Re: DeSabra-Centerville (FERC Project #803) Comments on Remaining Study Results

Re: DeSabra-Centerville Hydroelectric Project Water Temperature Modeling

Subject: Review Comments on CE-QUAL-W2 Models for DeSable Relicensing Project – Forest Service Agreement No. 08-IA-11050650-016

Figure 66: Model predicted water temperatures (flow weighted average from Models 9 and 10) compared with data measured at BC9, June 29th to July 19th, 2005.

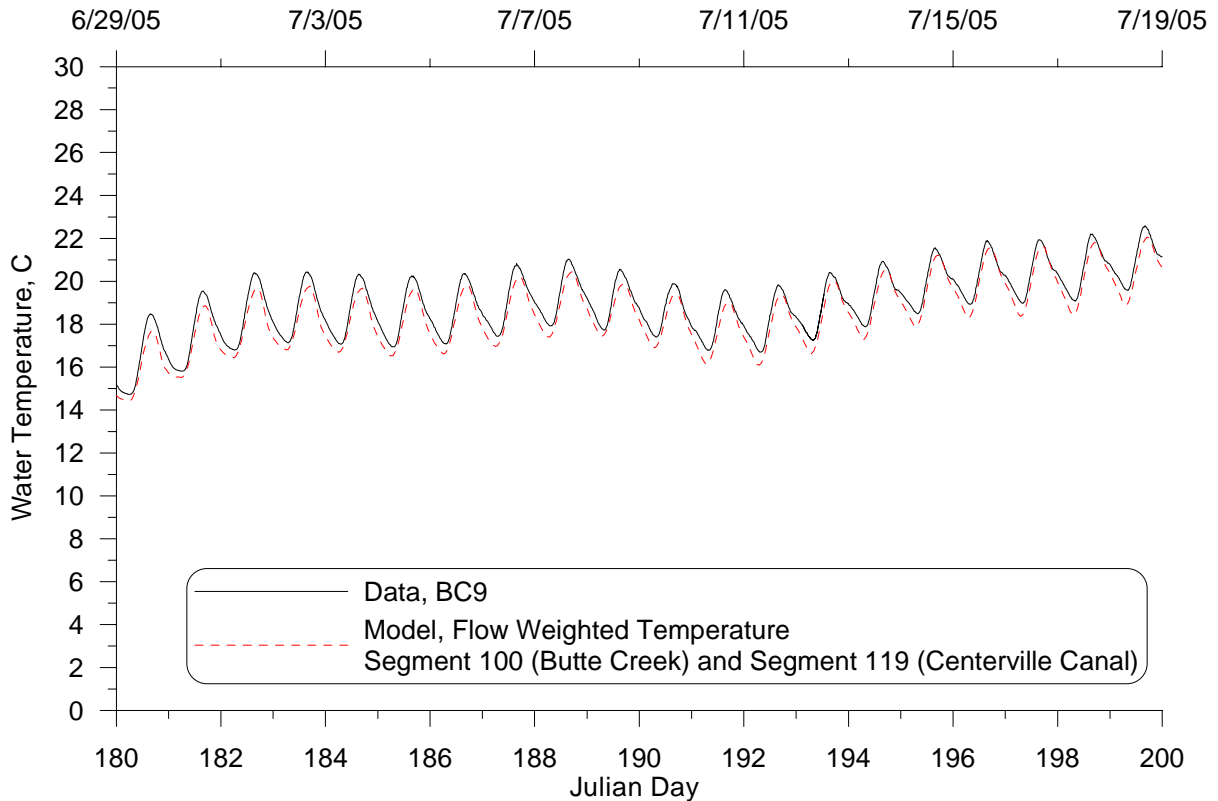
7) The following Figure 66 from the draft report, DeSabra-Centerville System Temperature Model: Model Update, by C. Berger, R. Annear, and S. Wells, January 2008 also shows some temperature differences and warm model results. However, overall the patterns track the observed warm temperatures sufficient enough for sensitivity analysis, planning, and appraisal level studies.
